## WEST SUSSEX COUNTY COUNCIL CONSULTATION

| <b>LOCATION:</b>                       | Land North of Water Lane<br>Angmering                                                                                                                                                                       |
| <b>SUBJECT:</b>                        | A/256/21/RES<br><br>Approval of reserved matters following outline consent A/40/18/OUT for the erection of 525 No residential dwellings with associated parking, landscape, play areas & public open space. |

### Parking

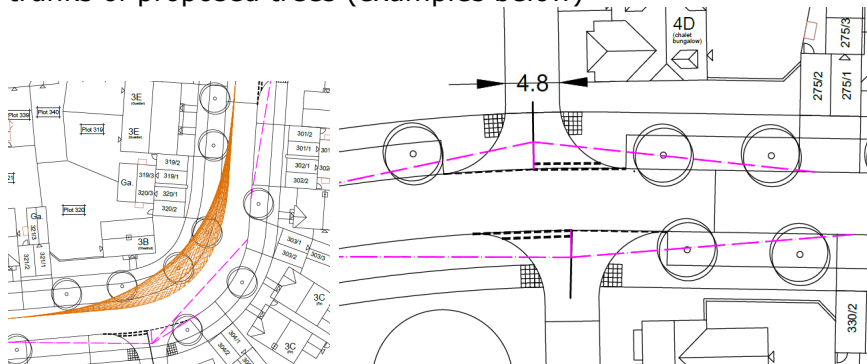
Parking levels are to be secured via conditions 17 of the outline application. It would be beneficial for the number of parking spaces to be provided.

The table in section 4.12 of the DAS indicates 20% of spaces will have EV charging capabilities. It should be noted that the Arun parking standards require 100% of Houses with a driveway or garage should be provided with EV charging.

#### Forward Visibility

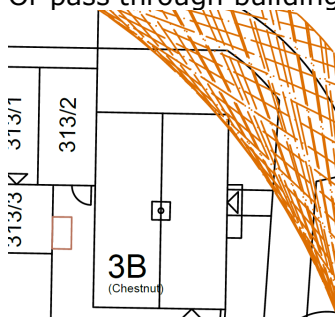
It is noted that a number of forward visibility splays and visibility splays run through the trunks of proposed trees (examples below)

Or pass through buildings

It is recommended that all visibility splays provided are checked by the applicant to ensure they do not pass-through buildings or are significantly impacted by the proposed planting.

#### Vehicle Tracking

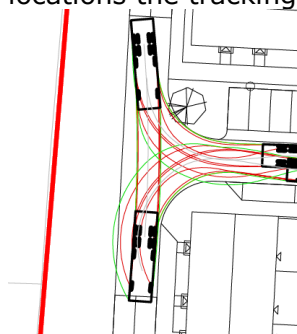
The refuse vehicle tracking should be rechecked by the applicant, in a number of locations the tracking over runs residential and visitor parking spaces.
